Mr. J. Robert Haines
TO: Zoning Commissioner
Date: March 24, 1988
P. David Fields
FROM: Director of Planning and Zoning
Zoning Petition Nos. 88-408-A,
88-409-A, 88-410-A, 88-411-A,
88-412-A, 88-413-A, 88-414-A,
88-415-A, 88-416-A, 88-417-A
SUBJECT: 88-414-A, 88-416-A, 88-417-A

RE: Item No. 244 - Case No. 88-414-A
Petitioner: Leroy Merritt/Lessee: Edgewood Corp.
Petition for Zoning Variance

McDonald's Restaurant
8655 Pulaski Highway
15th District Baltimore County, Maryland

PROPOSED EXTENDED BOOTH & VESTIBULE ADDITION

SP-1 of 1

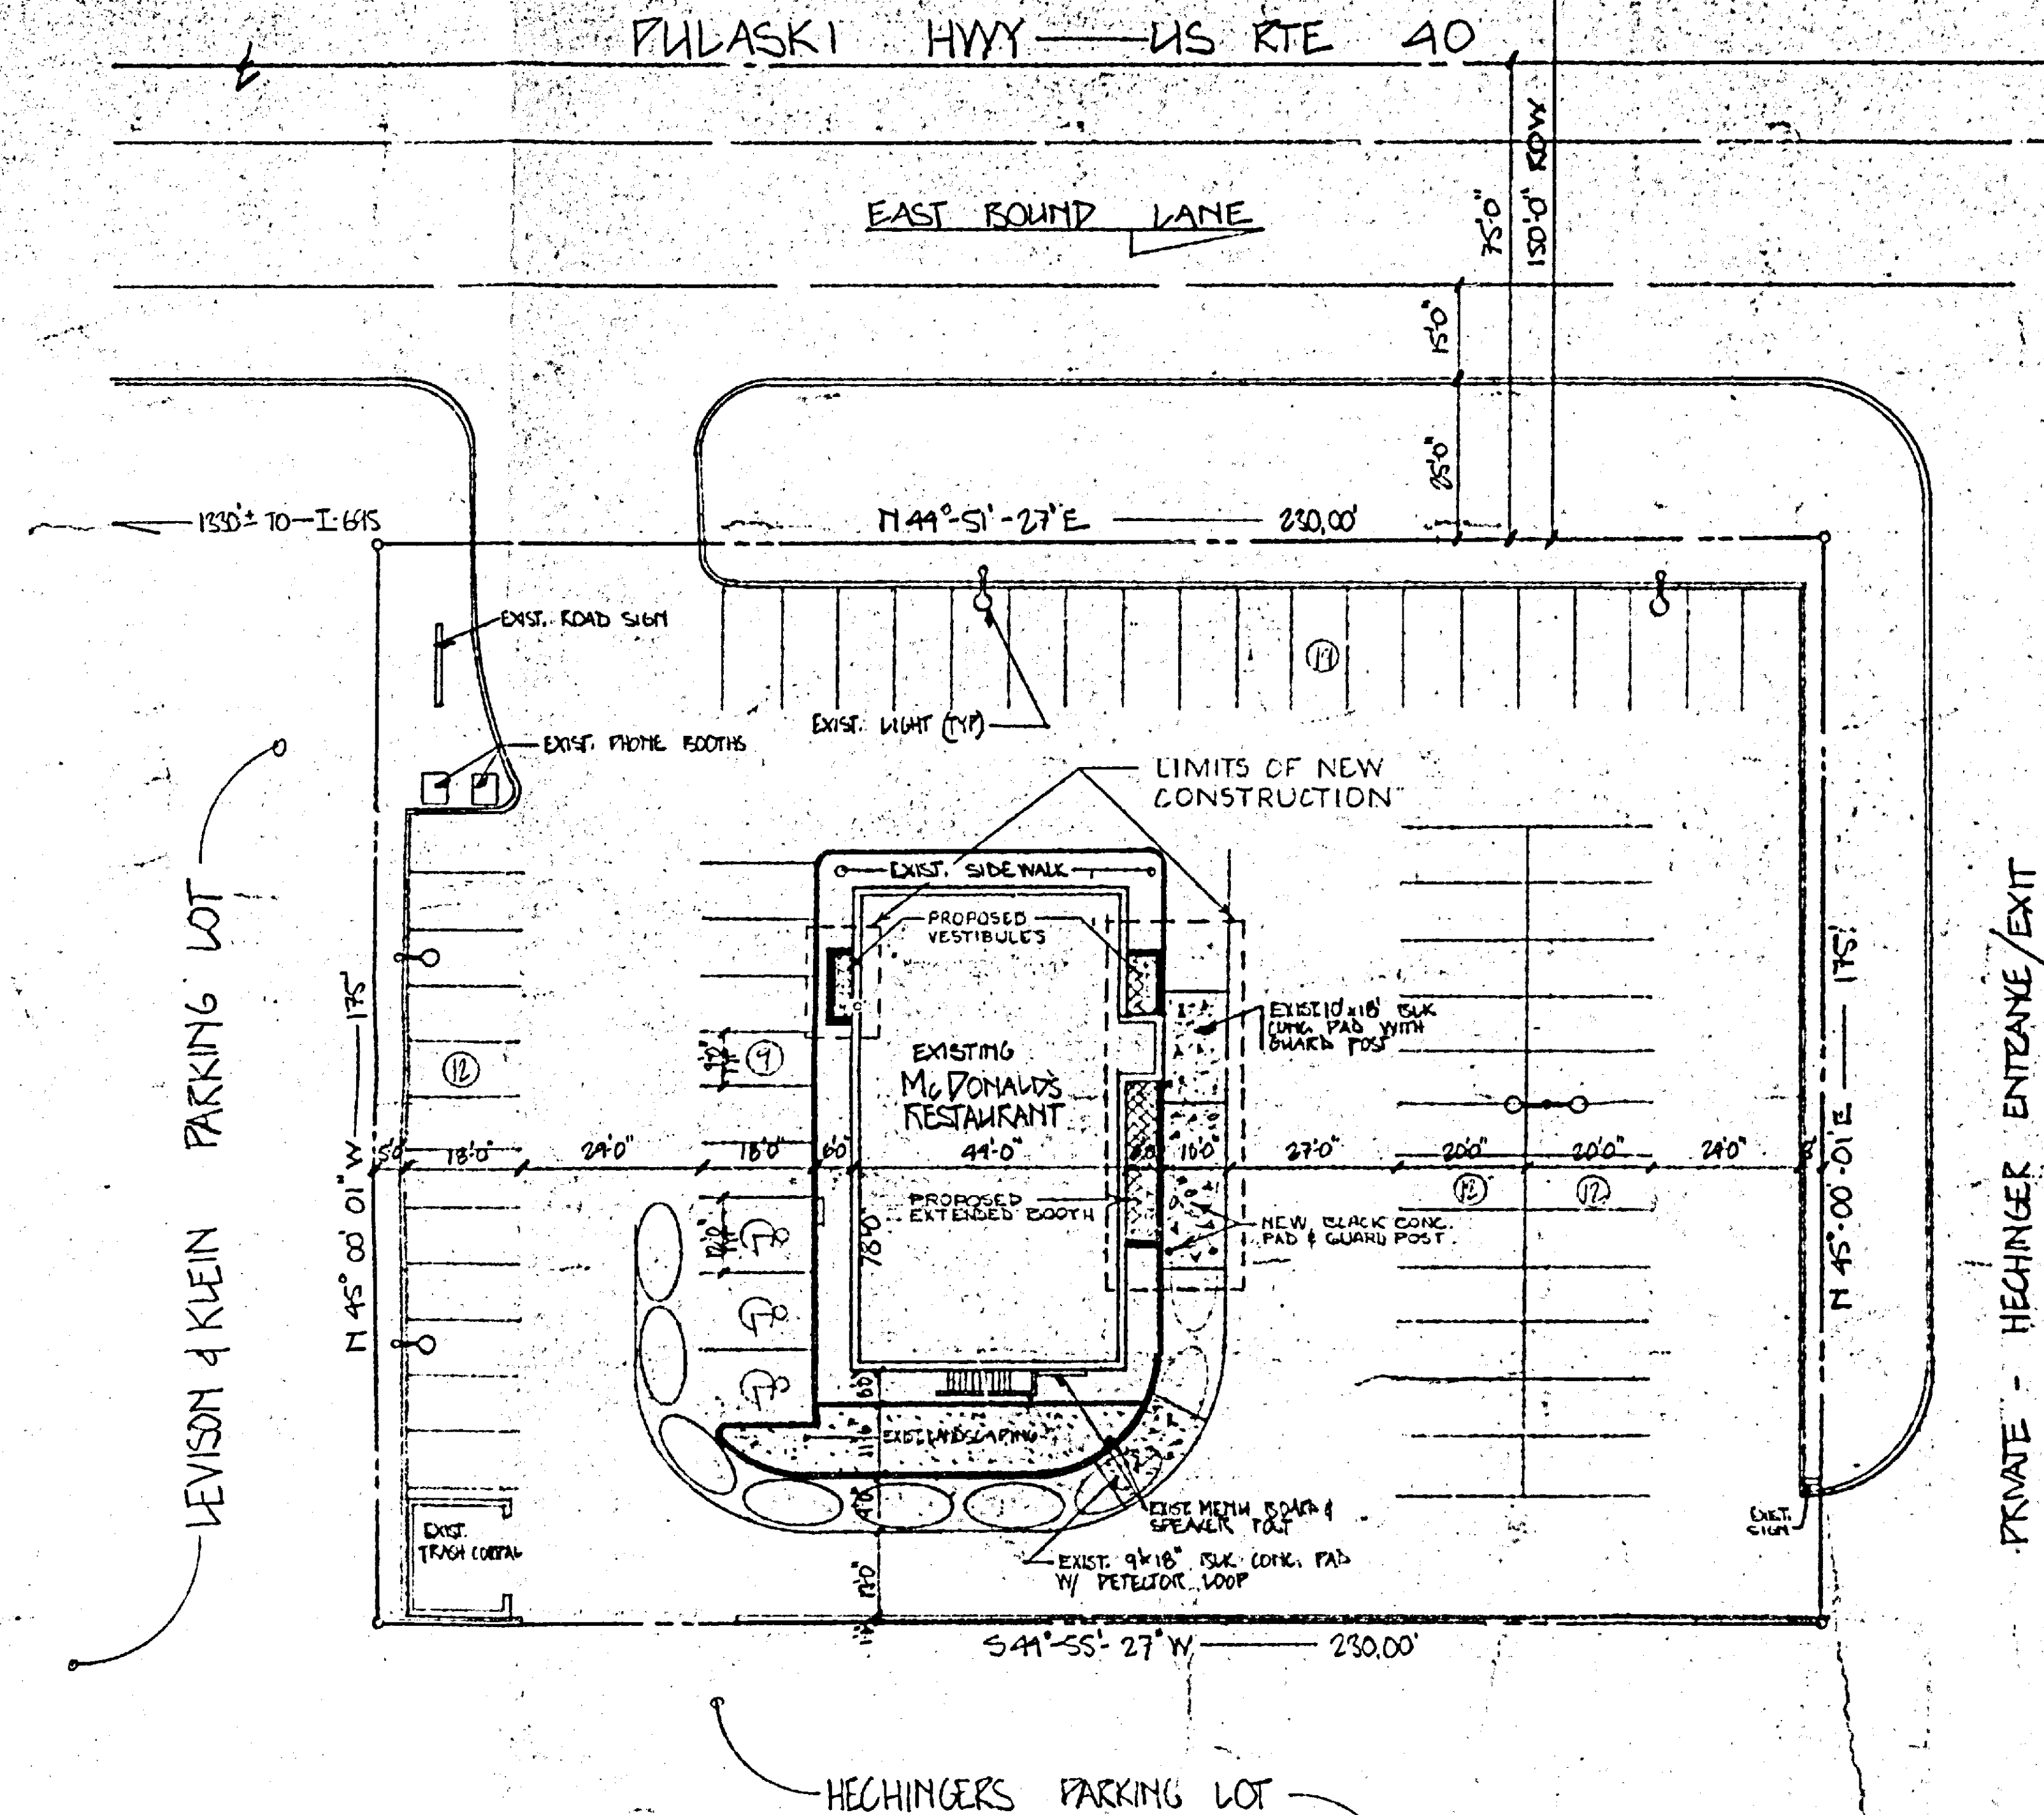
After reviewing the submittal dated April 22, 1987, for a variance to permit a required one parking space for each 50 square feet, the State Highway Administration-Bureau of Engineering Access Permits finds the plan generally acceptable.
